# Aberdeen Harbour Expansion Project

**Document Title:** Marine Scotland Act Part 4 Marine Licensing,  
Licence Number: 05964/16/0 Reference No: 05964  
Proposed Variation to Dredging Licence

Subject Dredge Depth & Area Amendments

### Extension of Dredge Depth

Drawing Title  
Results of sediment analysis  
in vicinity of South East Pier  
Heavy Metals

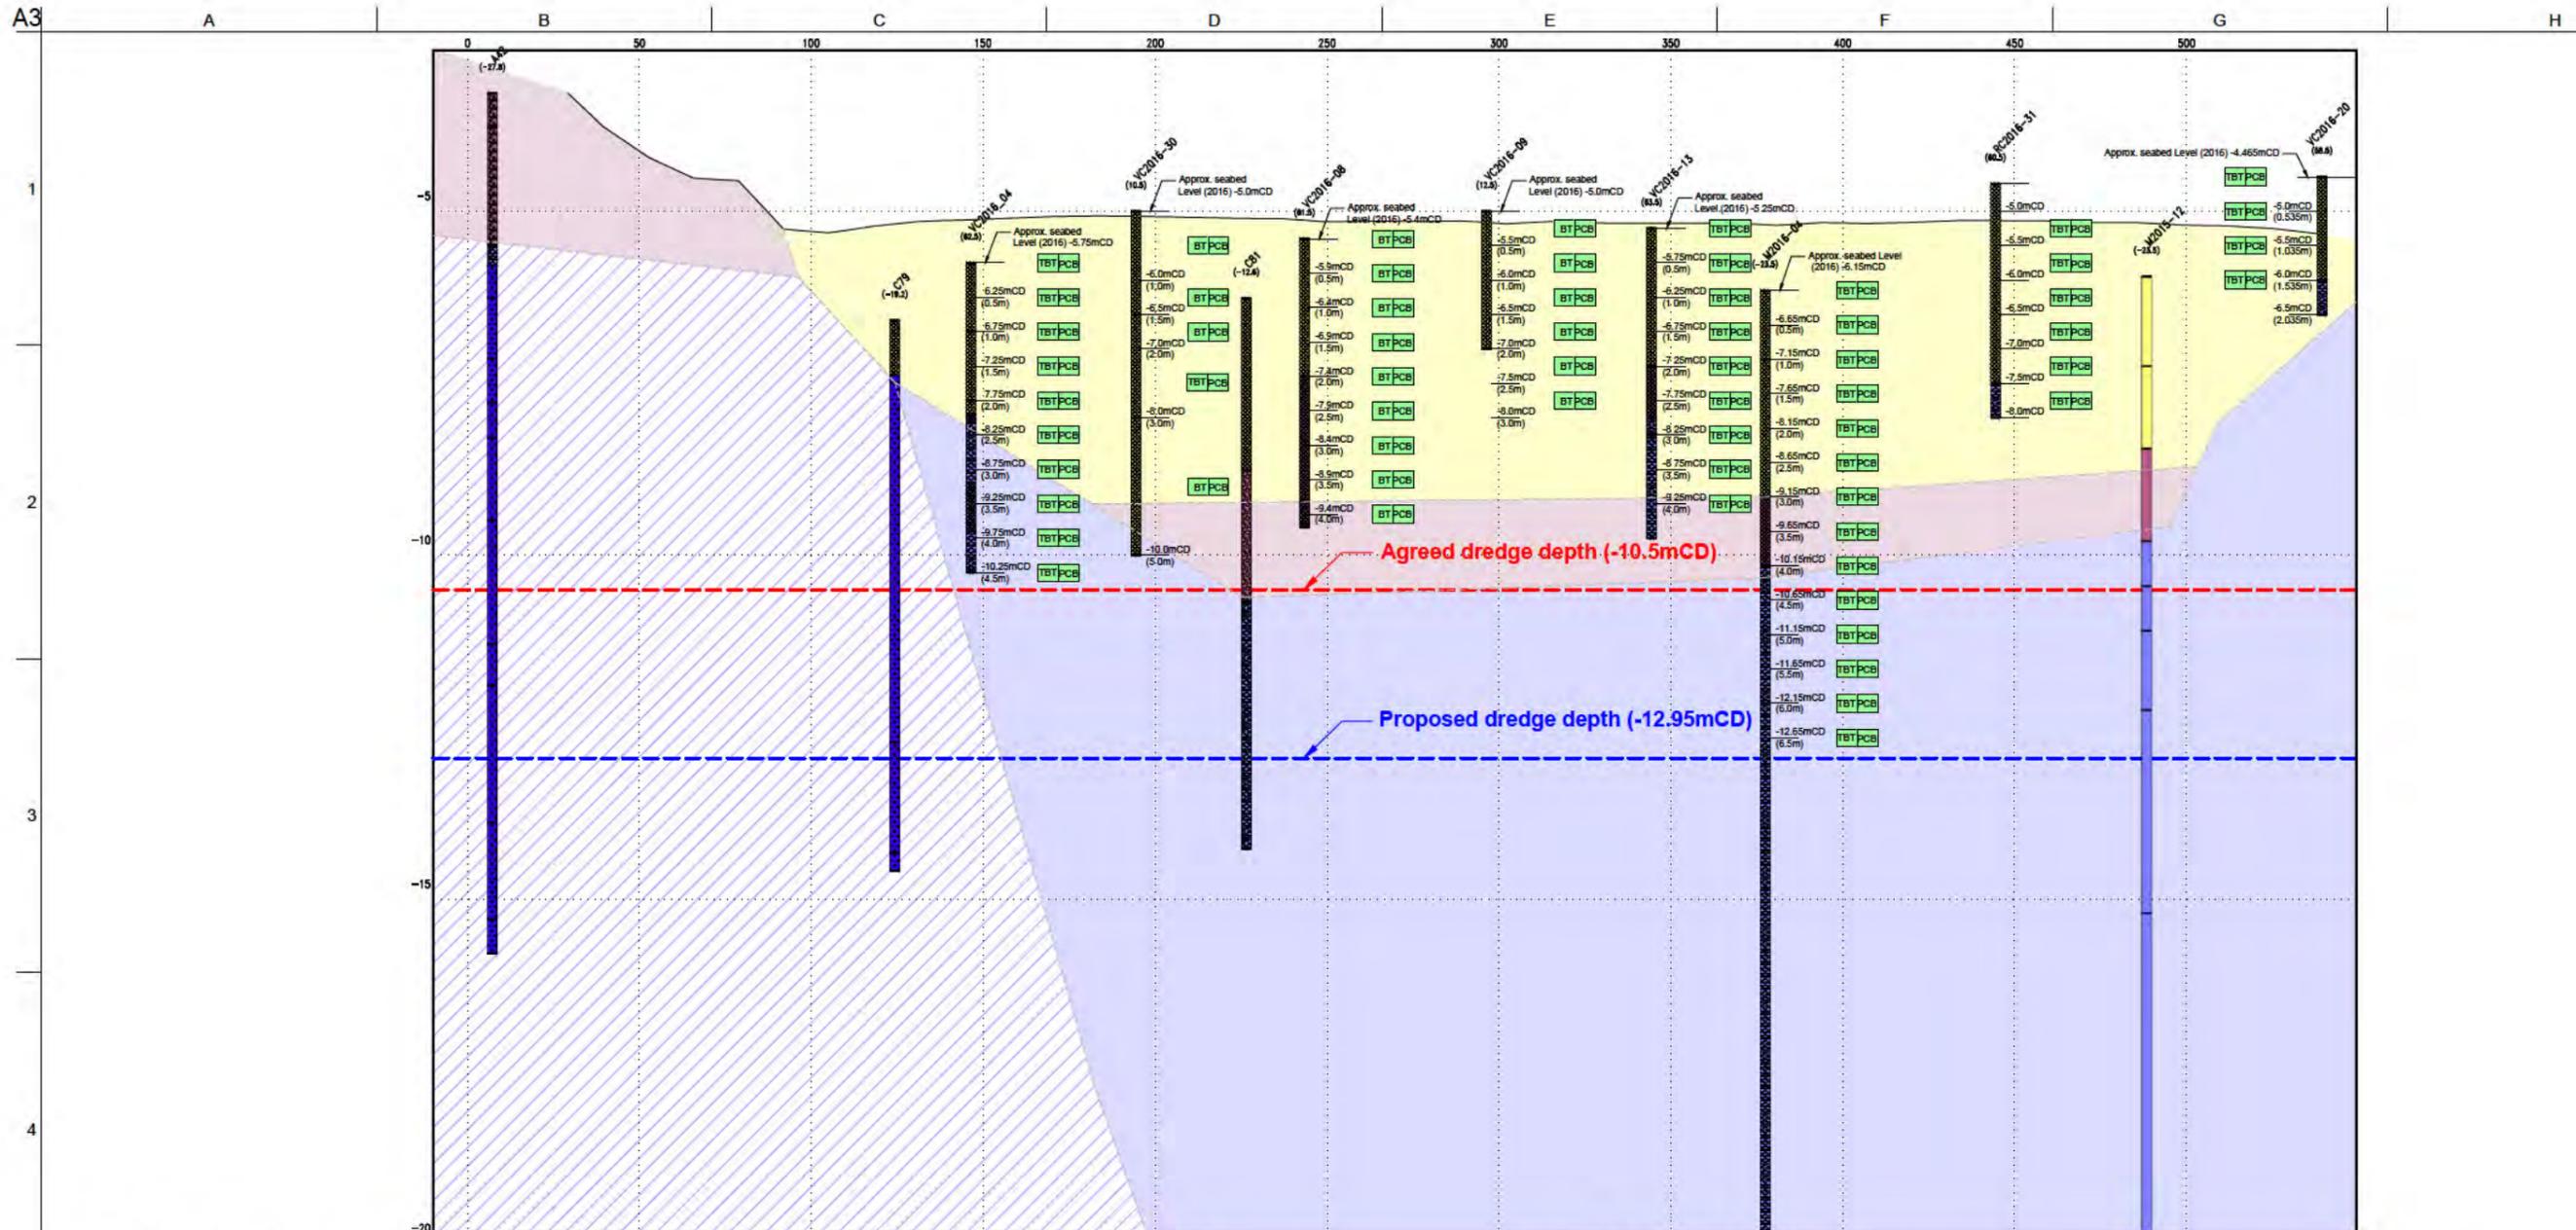
Figures 7 and 10 show that although some of the heavy metals were recorded at concentrations between action level 1 and action level 2 down to the proposed dredge depths, none of the concentrations exceed action level 2.

Drawing Title  
**Results of sediment analysis  
 in vicinity of East Quay  
 TBT & PCBs**

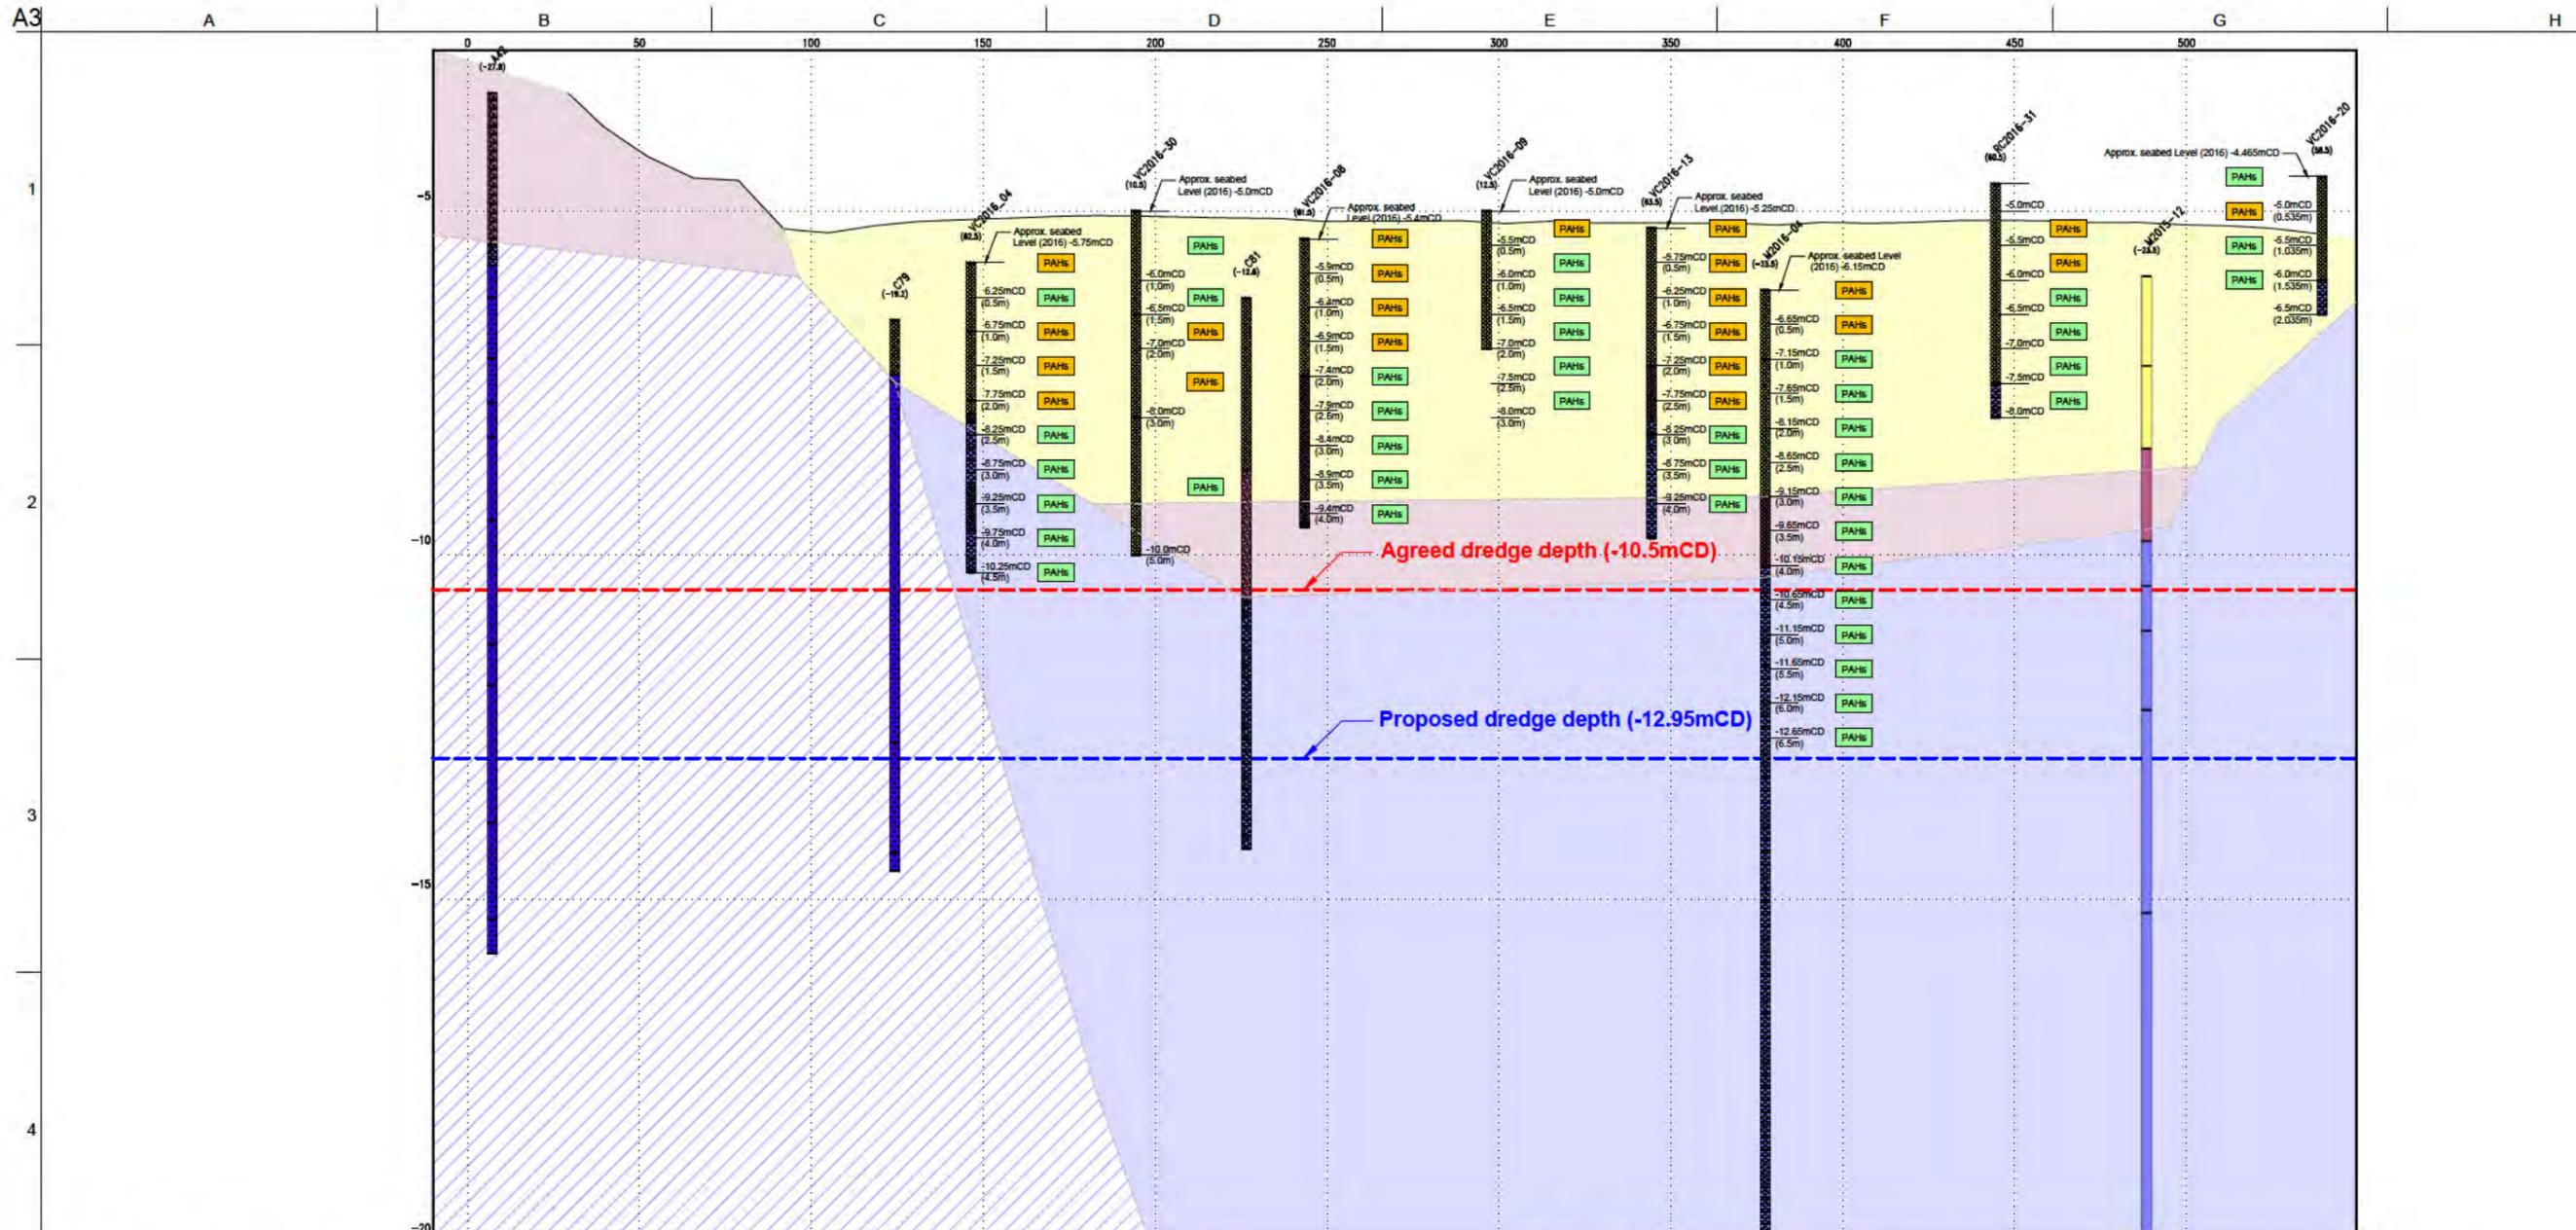
Figure 5 and 8 show that all of the PCB and TBT concentrations were recorded below action level 1.
